V2500 Propulsion System — Nacelle

SERVICE BULLETIN

**NACELLE - ELECTRICAL POWER - COVER ASSEMBLY, VSCF POWER FEEDER HARNESS
-REPLACEMENT OF**

V2500-NAC-24-0008

VSCF POWER FEEDER HARNESS COVER REPLACEMENT
FIGURE 1

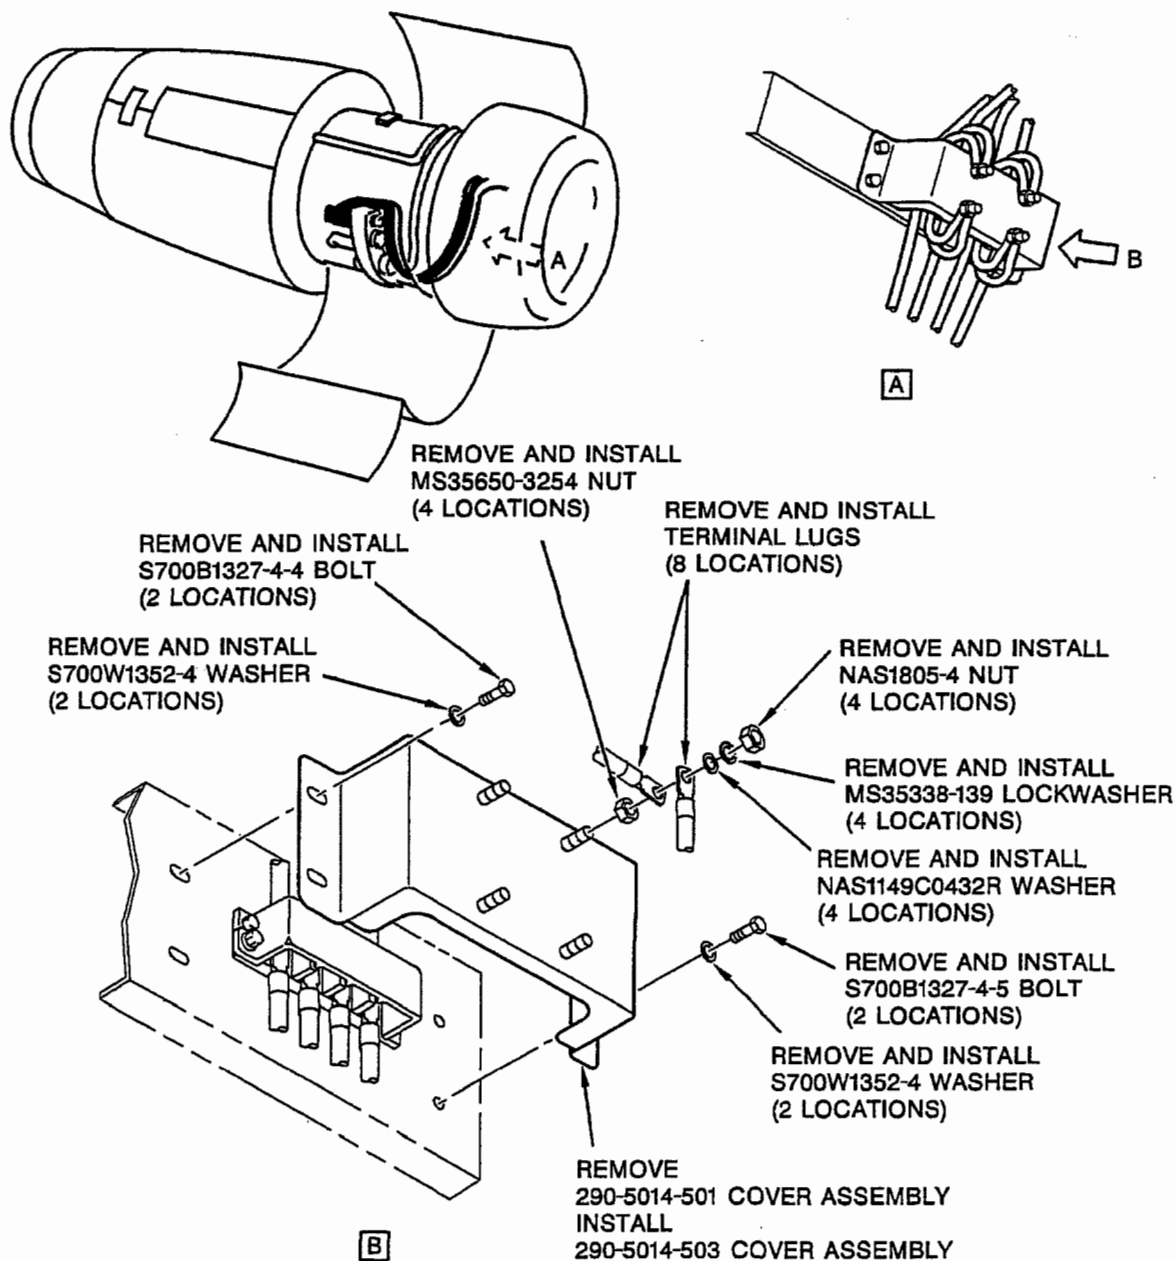
- (1) Remove and retain four NAS1805-4 nuts, four MS35338-139 spring washers, and four NAS1149C0432R washers which attach VSCF power feeder cable terminal lugs to cover assembly. Refer to Figure 1.
- (2) Remove eight VSCF power feeder cable ground pigtails.
- (3) Remove and retain four MS35650-3254 nuts from 290-5014-501 cover assembly.
- (4) Remove and retain two S700B1327-4-5 bolts, two S700B1327-4-4 bolts and four S700W1352-4 washers that attach the 290-5014-501 cover assembly. Remove and discard the 290-5014-501 cover assembly.
- (5) Install the 290-5014-503 cover assembly with four S700W1352-4 washers, two S700B1327-4-4 bolts and two S700B1327-4-5 bolts.
- (6) Install four MS35650-3254 nuts on 290-5014-503 cover assembly.
- (7) Install eight VSCF power feeder cable terminal lugs with four NAS1149C032R washers, four MS35338-139 spring washers, and four NAS1805-4 nuts.
